SUBJECT: ISSUANCE OF AMENDMENT NO. 60 TO FACILITY OPERATING LICENSE NO.
DPR-18, R. E. GINNA NUCLEAR POWER PLANT (TAC NO. M92188)

AMENDMENT TO FACILITY OPERATING LICENSE

Amendment No. 60
License No. DPR-18

SAFETY EVALUATION BY THE OFFICE OF NUCLEAR REACTOR REGULATION
RELATED TO AMENDMENT NO. 60 TO FACILITY OPERATING LICENSE NO. DPR-18
ROCHESTER GAS AND ELECTRIC CORPORATION
R. E. GINNA NUCLEAR POWER PLANT
DOCKET NO. 50-244

Figure 5.4-2
Fuel Assembly Burnup Limits in Region 2

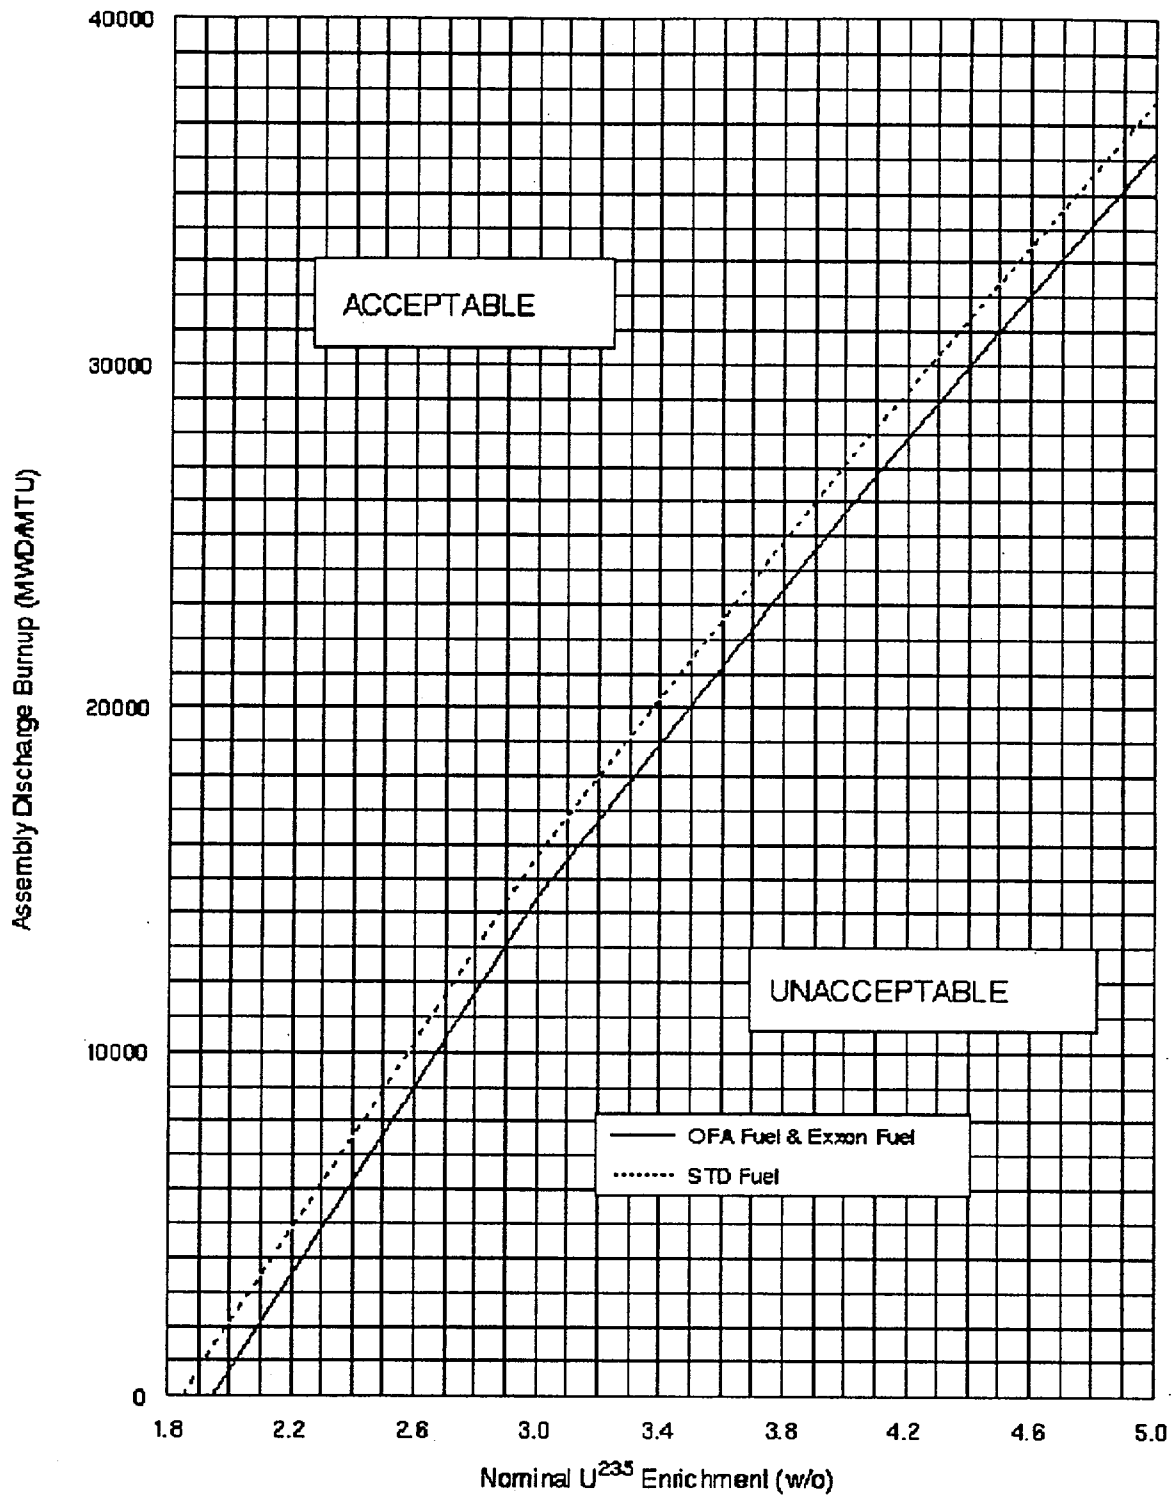
The two curves of Figure 5.4-2 divide the fuel assembly designs into two groups. The first group is all fuel except Exxon fuel delivered prior to January 1, 1984, which incorporates all Westinghouse HIPAR designs used at Ginna.⁴ The second curve is for all Exxon fuel, as well as the Westinghouse Optimized Fuel assembly design delivered to Ginna beginning in February 1984.³

The calculations of fuel assembly burnup for comparison to the curves of Figure 5.4-2 to determine the acceptability for storage in Region 2 shall be independently checked. The record of these calculations shall be kept for as long as fuel assemblies remain in the pool.

In order to store Westinghouse 14x14 OFA as well as Westinghouse STD and Exxon 14x14 assemblies with enrichments up to 5.0 w/o U-235, the concept of burnup credit reactivity equivalencing was used. This is predicted upon the reactivity decrease associated with fuel depletion and has been previously accepted by the staff for spent fuel storage analysis. For burnup credit, a series of reactivity calculations are performed to generate a set of initial enrichment versus fuel assembly discharge burnup ordered pairs which all yield an equivalent K_{eff} less than 0.95 when stored in the spent fuel storage racks. The results indicate that a fresh OFA 1.95 w/o enriched fuel assembly yields the same rack reactivity as an initially enriched 5.0 w/o OFA depleted to approximately 36,200 MWD/MTU. Since the Westinghouse 14x14 STD is more reactive than the Westinghouse 14x14 OFA fuel at the low enrichment limit for the Region 2 rack, a separate burnup credit curve was determined for the STD fuel. In addition, since the Exxon 14x14 fuel is less reactive than the Westinghouse OFA, the Westinghouse 14x14 OFA burnup credit curve may be used for the Exxon 14x14 fuel. A reactivity uncertainty of 0.0121 K (reactivity increase) was applied to the burnup credit curves. This is consistent with current practice and is acceptable.
